PMSTPCOL PEmails

Issue 3: Clearly describing in the FSAR how seismic demand for non-seismic II/I structures for stability evaluation is determined

Issue 7: SAP2000 V&V

Issue 9: DGFOSV Calculation U7-YARD-C-CALC-DESN-6001 Rev. B

Radwaste Building (RWB)
N-S Input Motion for Stability Evaluation (5% Damping)

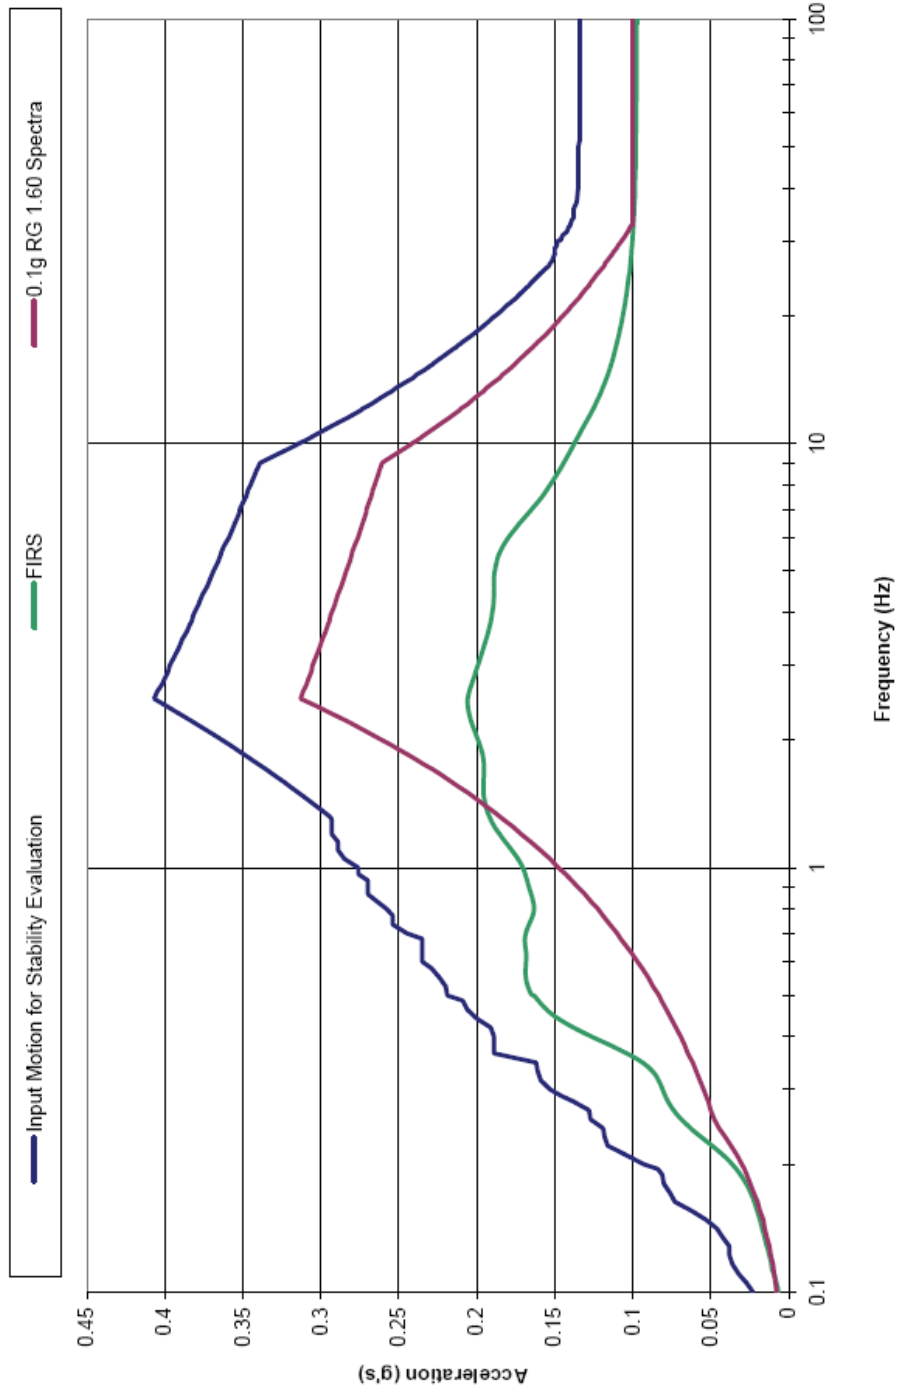
It is not clear from the descriptions in the FSAR as to how the seismic demand is determined for the site-specific stability evaluation of the non-seismic II/I structures considering the influence of nearby heavy structures during SSE. As such, the applicant is requested to describe in sufficient detail in the FSAR the following information:

2. How the effects of nearby heavy structures are included in the input response spectra for various soil and backfill conditions
3. Demonstrate that horizontal input response spectra at the foundation level of non-seismic II/I structures is broad band spectra with peak acceleration greater than 0.1g and envelops FIRS

5. Include 5% damped input response spectra (vertical and horizontal) as amplified by the presence of nearby heavy structures used in the seismic demand evaluation for site-specific stability analysis for non-seismic II/I structures

3. Attached Figures 1 through 6 show, for the two horizontal and vertical directions, a comparison of the input spectra derived from the analysis described in Items 1&2 above, with the 0.1g Regulatory Guide 1.60 spectra for the RWB and CBA.

It can be seen from these figures that the input spectra for stability analysis envelop the 0.1g Regulatory Guide 1.60 spectra for both structures in all cases.

5. The input spectra shown in Figures 1 through 6 will be included in COLA.
6. The different formulations for calculation of safety factors against sliding and overturning used in the stability evaluation of Category I and Non-Category I structures are shown in COLA Figures 3H.6-137 and 3H.3-52, respectively, submitted as part of the RAI 03.08.04-30, Supplement 1 response, with NINA letter U7-C-NRC-NINA-110042, dated March 7, 2011. Copies of these figures are shown below as Figures 7 and 8.

Figure 3H.6-137: Formulations Used for Calculation of Factors of Safety Against Sliding and Overturning

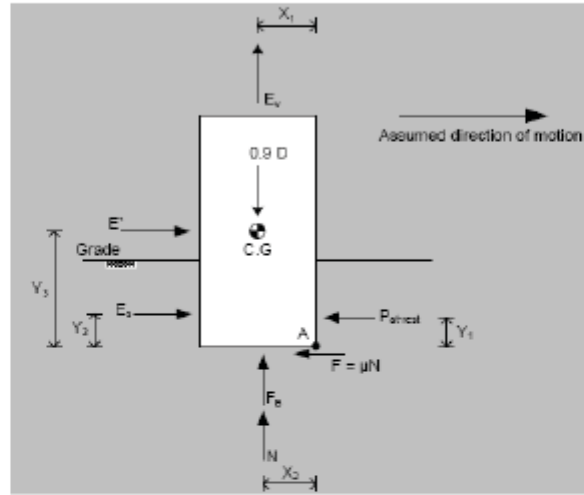
6. Discuss or refer to appropriate FSAR section of any differences in the method of stability evaluation from that of Category 1 structures

Figure 9

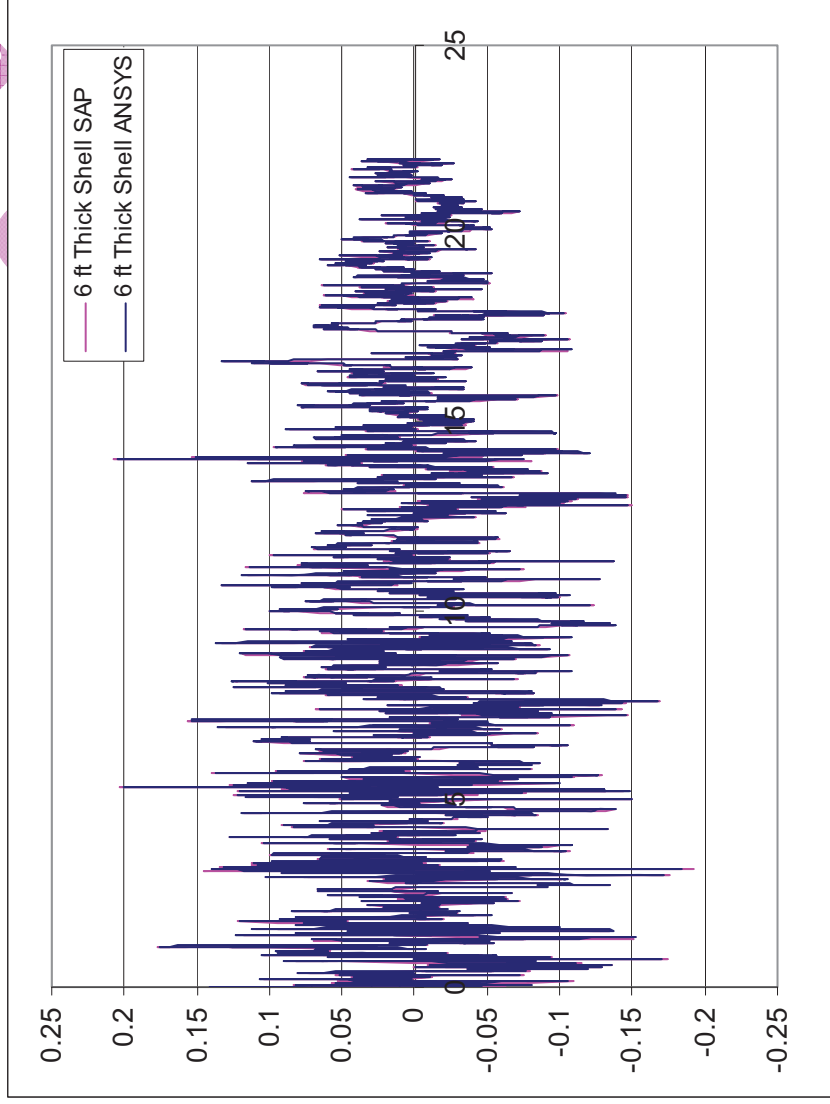
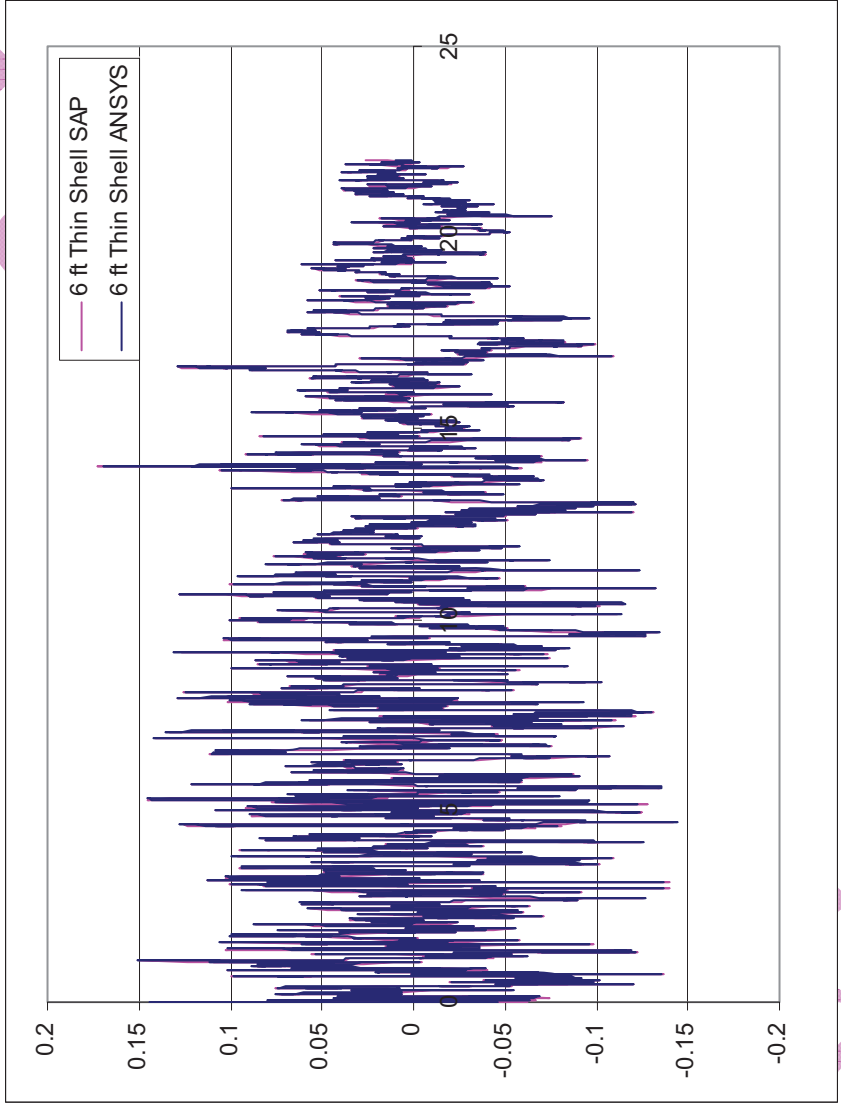
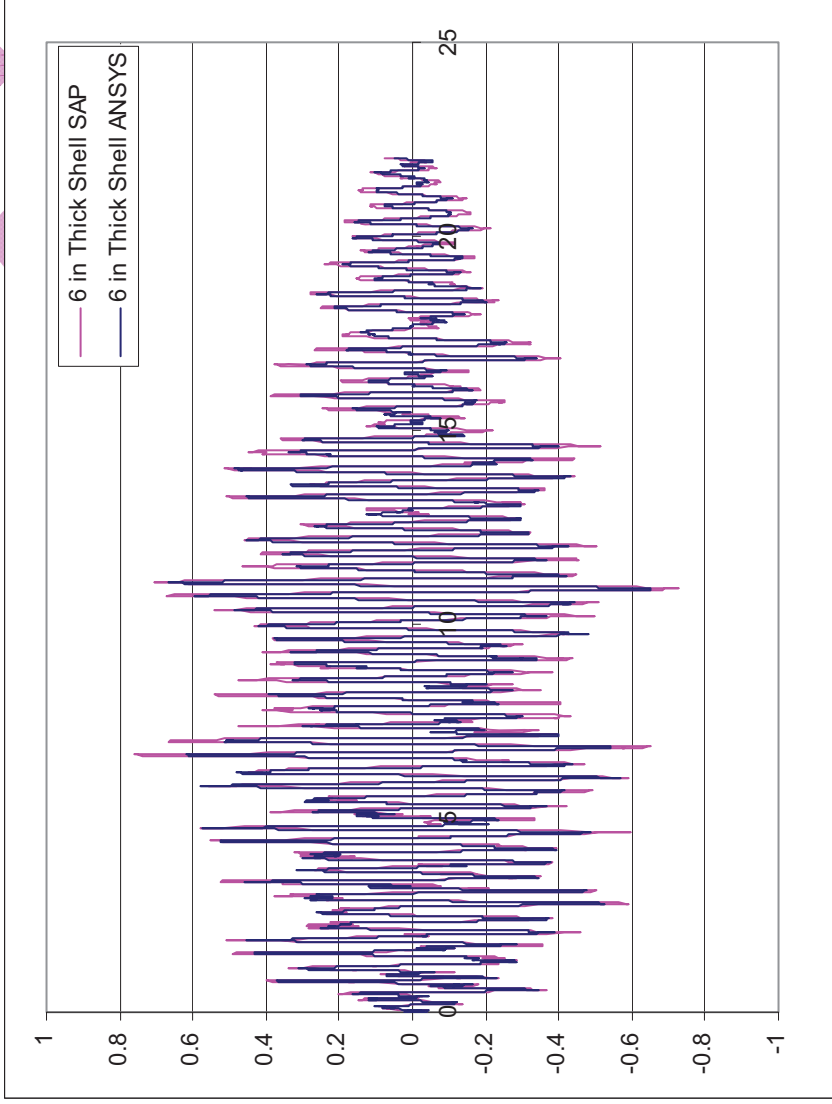
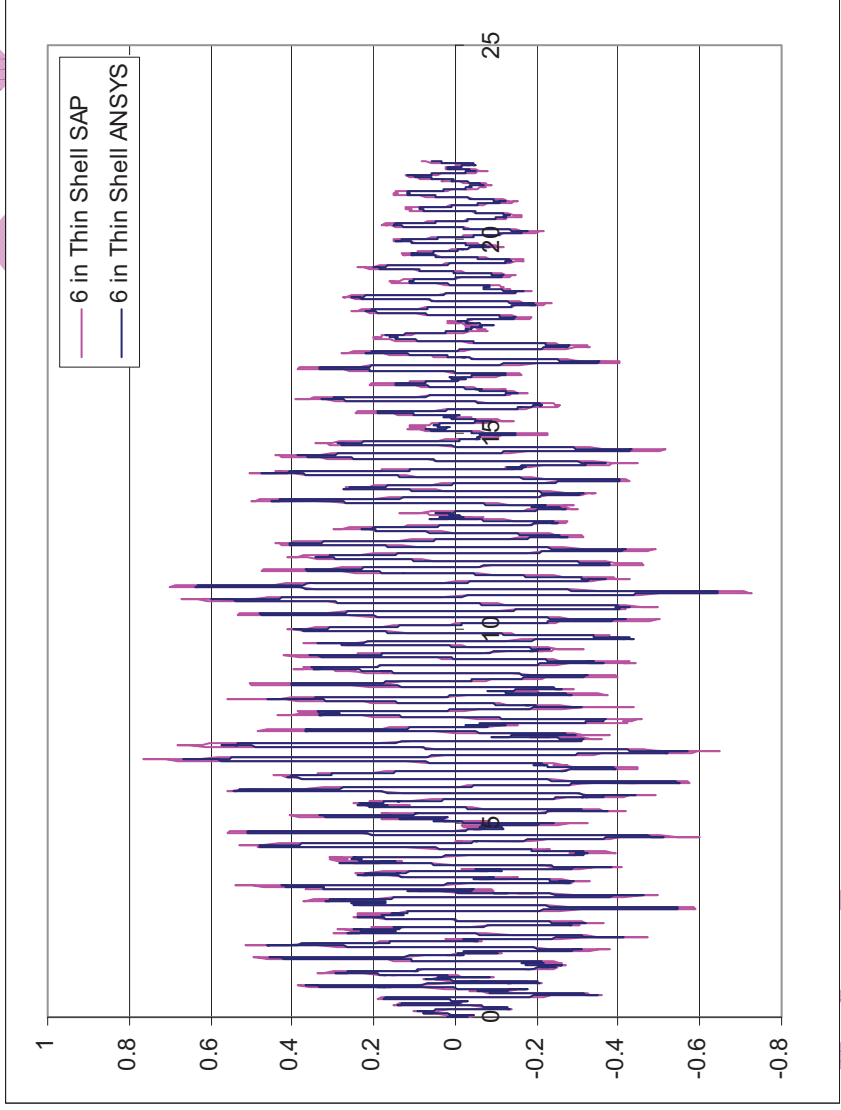
Validation of item “1” was done by hand calculation. For items “2”, “3” and “4”, the benchmark solutions for validation were developed with ANSYS utilizing “SHELL43” element, which is well suited to model linear, warped, moderately-thick shell structures according to ANSYS User’s Manual. For items “2”, “3” and “4”, the following acceptance criteria were used: 5% for frequencies, 10% for forces, and 15% for spectra. The 5% difference is considered acceptable within the engineering accuracy, while the 10% and 15% criteria may be excessive. The applicant is requested to assess the impact of the above acceptance criteria on the STP 3&4 design.

The higher difference in forces and spectra is mainly due to differences in the SAP2000 and ANSYS element formulations. As a result of these differences, the generated acceleration time histories from the two programs are somewhat different. Figures 9 through 12 show the comparison of the generated acceleration time histories.

The forces and spectra generated from the SAP2000 program application used for the mesh sensitivity study are not used for design. Therefore, the above acceptance criteria have no impact on STP 3&4 design.
